Access Compliance Report

Public Rights-of-Way (Curb Ramps)

Intersection ID: 14632	Main Street: FARM_POND_LN	Cross Street: MOCK_ROBIN_LN	Location: NE
ADA ID: A53F62474D5A	Ramp Type: Directional1	Initial Pass/Fail: Fail	Overall Compliance: No
		Severity Score: 10

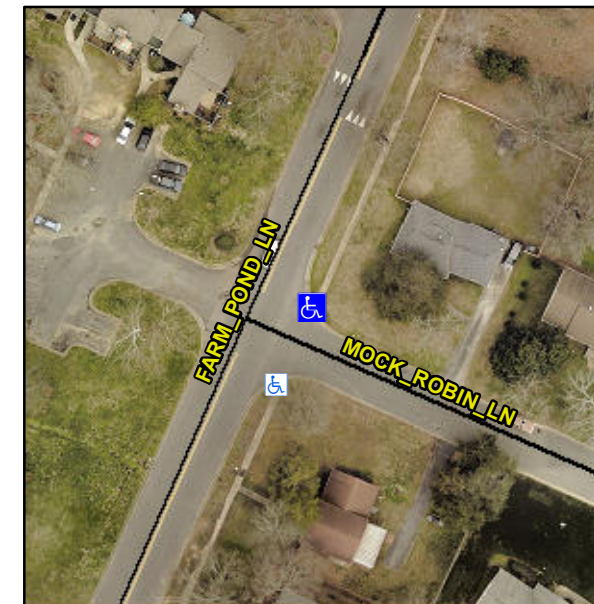
R304.5.1, R304.5.3

Compliance	Description	Data	Compliance	Description	Data
N/A	Ramp Length (in)	73.5	N/A	Grade Break?	N/A
No	Ramp Width (in)	42.0	N/A	Grade Break Slope (%)	0.0
Yes	Ramp Slope (%)	6.3	N/A	Grade Break XSlope (%)	0.0
No	Ramp XSlope (%)	4.5			
N/A	Flare Type LT	N/A	N/A	Flare Type RT	N/A
N/A	Flare Slope LT (%)	N/A	N/A	Flare Slope RT (%)	0.0
N/A	Flare Traversable LT?	N/A	N/A	Flare Traversable RT?	N/A
N/A	Landing Length (in)	0.0	N/A	DWS Provided?	N/A
N/A	Landing Width (in)	0.0	N/A	DWS Contrast?	N/A
N/A	Landing Slope (%)	0.0	N/A	DWS Length (in)	N/A
N/A	Landing X Slope (%)	0.0	N/A	DWS Full Width?	N/A
N/A	Landing Curb? (Y/N)	N/A	N/A	DWS Offset LT (in)	N/A
N/A	Shared Landing?	N/A	N/A	DWS Offset RT (in)	N/A
N/A	Gutter Ponding?	0.0	N/A	Gutter Slope (%)	N/A
N/A	Gutter Lip Ht (in)	0.0	N/A	Gutter X Slope (%)	N/A
N/A	Painted X Walk1?	No		Road Slope (%)	0.7
	X Walk 1 Direction	To S		Road X Slope (%)	1.6
	X Walk 1 Width (in)	N/A		Clear Space?	N/A

Remove & Replace Entire Ramp.
